APPENDICES

INDIAN INSTITUTE OF TECHNOLOGY HYDERABAD	
CONCEPT DESIGN  THE UNIVERSITY OF TOKYO IITH CAMPUS DESIGN STUDIO Faculty of Engineering Building 1, Rm#331 7-3-1 Hongo, Bunkyo-ku, Tokyo 113-8656, JAPAN	
ARCHITECT/ENGINEER  NIHON SEKKEI INTERNATIONAL INC. NIHON SEKKEI INC. 6-5-1 Nishi-Shinjuku, Shinjuku, Tokyo 163-1329 JAPAN	
ASSOCIATE ARCHITECT  APL DESIGN WORKSHOP INC. 4-2-1 Yushima, Bunkyo-ku Tokyo 113-0034 JAPAN	
ARCHITECT OF RECORD  ASTUTE™ ENGINEERING SERVICES PVT. LTD. 9 & 10, Symphony C, Range Hills, Bhosale Nagar, Pune - 411 020, (India)	
LOCAL STRUCTURAL CONSULTANTS:  JW CONSULTANTS LLP Consultants for all types of structural work	PUNE OFFICE 201 CHAMBERS, 16, PUNE-MUMBAI ROAD, WANDERWADI, PUNE-411003. Tel: 020-2544 6014 / 2546 5920 / 3252 2069 Fax: 020-2543 6684 MUMBAI OFFICE 314, 3RD FLOOR, PRABHADEVI INDUSTRIAL ESTATE, VESR, SAVARKAR MARG, PRABHADEVI, MUMBAI-400025 Tel: 020-2544 6014 / 2546 5920 / 3252 2069 Fax: 020-2543 6684

ISSUED FOR DESIGN DEVELOPMENT 100%
OCTOBER 31ST, 2014

Fig.1 : The Concept of Power Supply System

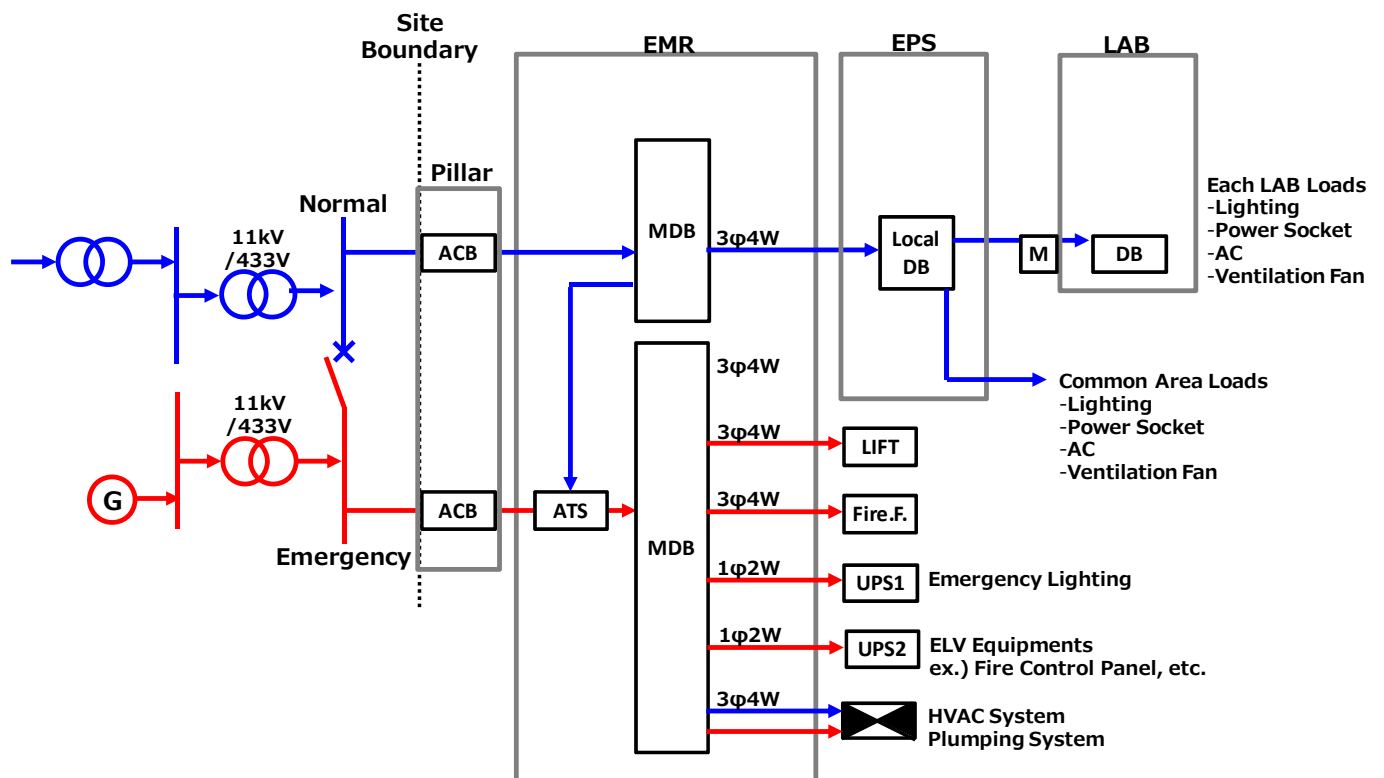
5.	POWER SUPPLY SYSTEM	
	<ul style="list-style-type: none"> ● NSI and AST discussed about “the concept of power supply system” as <i>the figure 1 in Attachment.</i> →<i>Same as Phase II</i> ● RCC is similar to TIP. And, KNC is similar to CONV. <p>1. Between Substation and MDB in EMR</p> <ul style="list-style-type: none"> ● Electrical L.T line between Substation and MDB shall be two following lines each for both RCC and KNC. <ul style="list-style-type: none"> - Normal line - Emergency line connected to generators on campus ● “Piller Box” shall be located at the site boundary on electrical L.T line. ● The cabling goes underground and goes into the pit. Then, it goes up from the bottom of EPS to MDB in EMR. <p>2. Between Normal MDB and Emergency MDB</p> <ul style="list-style-type: none"> ● Normal MDB and emergency MDB are connected by ATS. <p>3. Between MDB and Local distribution boards</p> <ul style="list-style-type: none"> ● EPS shall be planed in each area in the buildings. And, local DB shall be located in EPS and MR. ● As to RCC, each LAB has distribution board one by one. And, LAB DB is connected with local DB through the meter. <p>4. The discrimination between normal and emergency loads</p> <ul style="list-style-type: none"> ● The following loads are discriminated to emergency loads. <ul style="list-style-type: none"> -Emergency lighting -Server rack -CCTV equipments -Amplifier -Fire alarm panel -PBX -Lift -Plumbing system -Fire fighting system <p>5. The loads of UPS</p> <ul style="list-style-type: none"> ● 2 kinds of UPS shall be planed. One is for emergency lighting. And, the other is for ELV equipments. ● AST to review the layout of EMR. <p>EMR; Electrical Machine Room MDB; Main Distribution Board Local DB; Local Distribution Board EPS; Electrical Pipe Shaft</p>	AST

Fig.2 : The Concept of Communication System

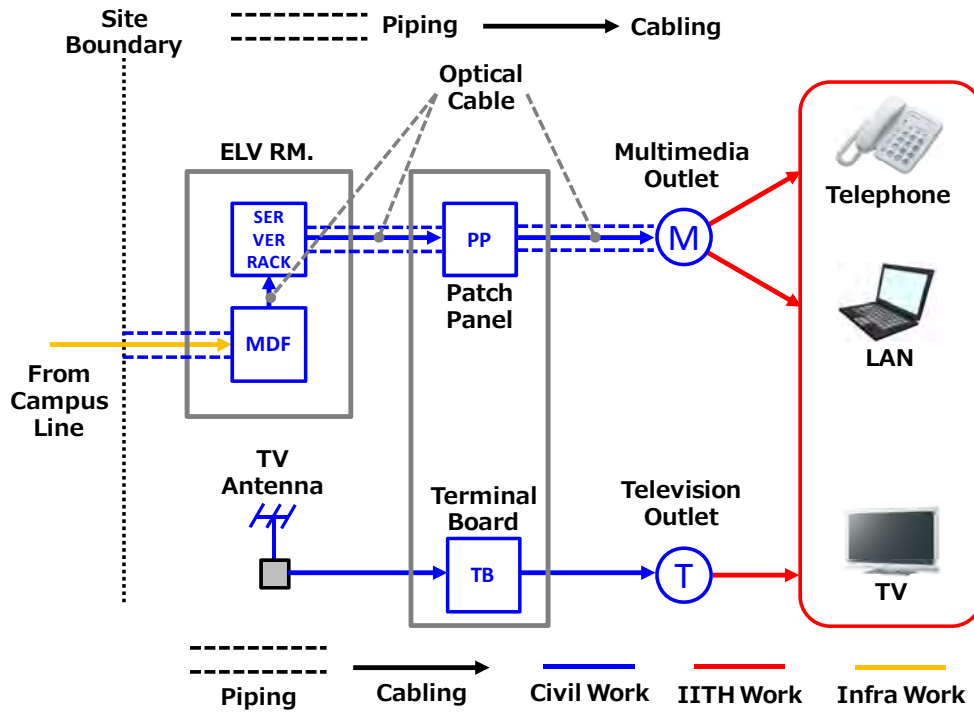
10.	TELEPHONE SYSTEM	
	<ul style="list-style-type: none"> NSI and AST discussed about “the concept of communication system” as <i>the figure 2 in Attachment</i>. NSI and AST plan unified communication system with telephone, LAN by optical cable. Television system is separated from this system. MDF and server rack are located in ELV room. The cabling route from MDF in ELV room to local patch panels is the same as power cabling. →<i>Same as Phase II</i> NSI indicated multimedia outlet layout by “NS drawings”. <p>ELV: Extra Low Voltage</p>
